CENTRAL COALFIELDS LIMITED
(A Subsidiary of Coal India Limited)
OFFICE OF THE PROJECT OFFICER
VTC BHAVAN, HONHE
AMRAPALI - CHANDRAGUPT AREA

Sub: Request for compliance of EDS, raised by MoEF&CC with regard to Forest proposal of the forest Land of 699.38Ha of Chandragupt Project of CCL.

Ref: EDS raised by the MOEF&CC, Dated: 22/09/2023

Kindly find the compliance to the EDS raised by MoEF&CC dated 22.09.2023 with regard to Forest Proposal of Chandragupt Project of CCL and the details are given below:

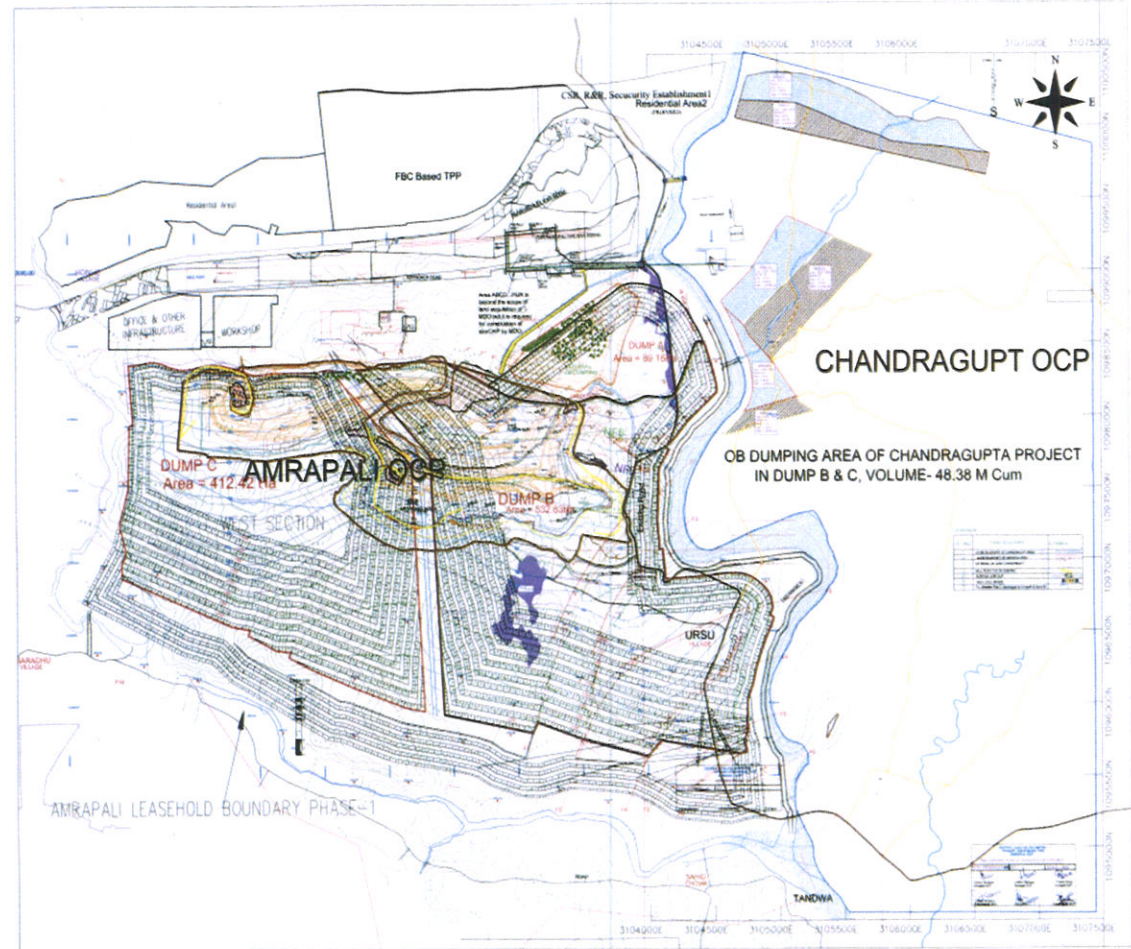
vi)	From the purpose-wise breakup of forest land, the following may be ascertained:

a)	An area of 0.14 ha has been proposed for diversion of Nadi/nalla. The status of feasibility reports for said diversion along with comments of Water Resource Department on the feasibility of said proposed diversion needs to be informed by the State.	<div>1) Chotki stream is a 2nd order and purely a rain-fed stream passing in the north-west of the block from North to south. Diversion of Chotki stream and straightening of the meander notch of Barki River (100 mtrs) are proposed.</div> <div>2) A DPR of Chhotki Stream diversion and straightening of the meander notch of Barki River has been prepared by IIT Roorkee. (The DPR enclosed in the form of CD as Annexure VII). Diversion proposal has been recommended by Chief Engineer (Water Resources Department), Jal Bhawan, Ranchi for issuance of NOC. (The recommendation is enclosed as Annexure VIII).</div>																																																														
b)	An area of 13.94 ha of forest land has been proposed for infrastructure while only 2.3 ha only has been proposed in non-forest land. The State Government may therefore assess the legitimacy of site-specificity of various infrastructural components and possibility to shift non-site-specific components to the non-forest land.	<div>As per the advice of MOEFCC, the land-use proposed in the earlier submitted Form-A has been revised with a view to reduce forest land for infrastructural components. The earlier and proposed land-use is given below:</div>

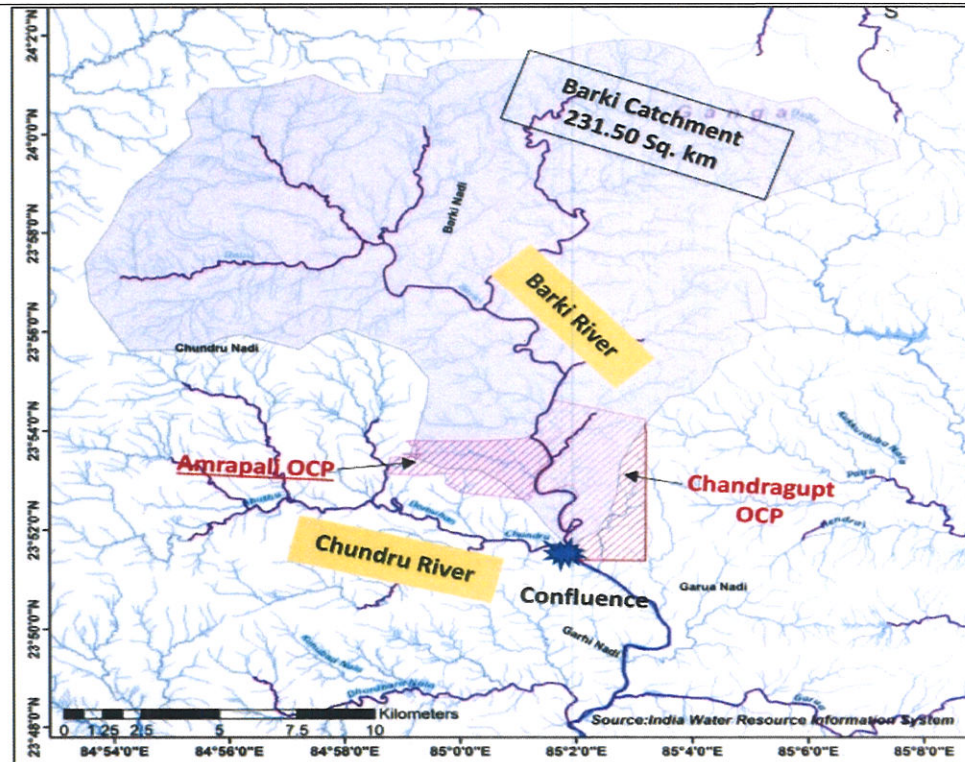
vii Analysis of the area proposed for diversion and area proposed for CA area using DSS analysis revealed the following which needs clarification:

a)	Google imagery shows the presence of Settlements, Roads and Agriculture land etc. within the proposed forest land for diversion	<p>The roads passing through the Forest area within the coal block will be diverted from outside the Coal block boundary along with shifting of village habitat and encroachers at the time of commencement of mining operations. In this regard a request to Road Construction Department (RCD), Govt of Jharkhand was submitted on 15.12.2022 for diversion of the existing road within the project boundary. Subsequently, RCD carried out site inspection of the said road and Executive Engineer RCD requested Chief Engineer RCD for the preparation of DPR for diversion. (Correspondence letters enclosed as Annexure XII).</p> <p>At the time of handing over of forest land for mining activities necessary support will be extended to forest department to make forest area encumbrance free land within coal block.</p>

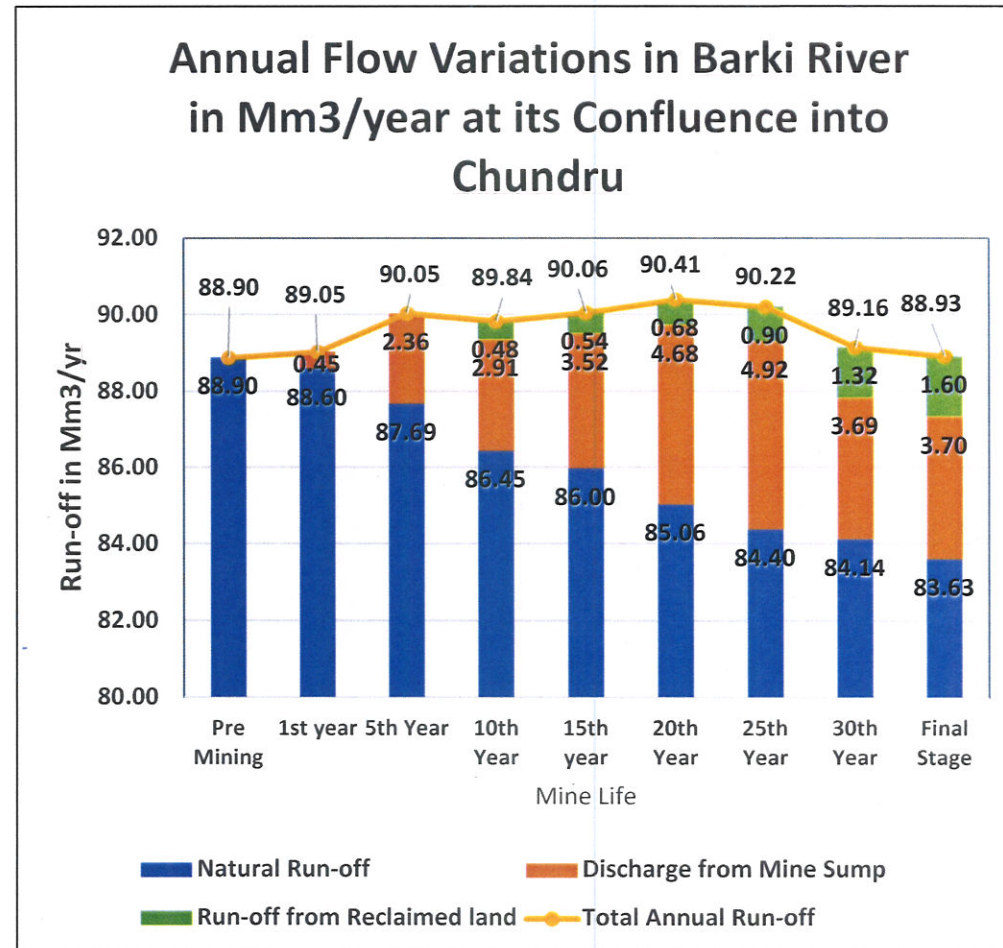
x)	In case Amrapali OCP is not of the UA then an NOC from the UA of Amrapali OCP shall be submitted.	Both Amrapali OCP and Chandragupta OCP are the projects of Central Coalfields Limited under the administrative control of 'Amrapali & Chandragupt Area'. As such, no NOC is required for Chandragupta OCP from Amrapali OCP.
xi)	Amrapali OCP boundary is in the west side of the Barki river, the impact of having mining on both the sides of river will require deep understanding of the impact of hydrology of the river, so comments of the State shall be submitted in this regard.	CMPDIL, Ranchi has prepared a Report on the anticipated impacts of proposed mining on either side of Barki River and its management plan. (Report of CMPDIL is attached as Annexure-XVIII). Following are the key findings of the report: 1) There shall not be any obstruction to the flow of Barki River. Mining is proposed by leaving approx. 100 m on Amrapali side and 60 m on Chandragupt side from the HFL of the River. 2) This safety zone will act as a buffer between the natural stream and active mining area, thereby safeguarding the banks of Barki River from erosion, keeping the catchment area for stream assisted by natural channel slope, sustaining the stream flow, and preserving the riverine eco-system. 3) During heavy rainfall conditions, the active mine sumps will act as surge ponds and effectively reduce the peak flow rates in Barki River. Thus, Barki River will not experience any flooding-related problems during heavy rainfall. Additionally, as part of the study on diversion of Chutki nalla, IIT Roorkee has conducted a study on Barki river also. The study states that Barki has a catchment of 231.50 sqkm.

The Barki watershed and the corresponding locations of the Amrapali and Chandragupt mines are depicted in the above figure. It can be observed that both Amrapali and Chandragupt mines are located in the southernmost portion of the Barki watershed, at its confluence with Chundru stream.

Of the entire Barki catchment area of 231.50 sq. km, only 6.40% (=14.94 sq. km) is designated for mining under both Amrapali and Chandragupt. It is to note that annual run-off from Barki River catchment is 88.90 Mm³, majority of which is contributed by belly portion falling in North and North-East part which remains unaltered by mining.
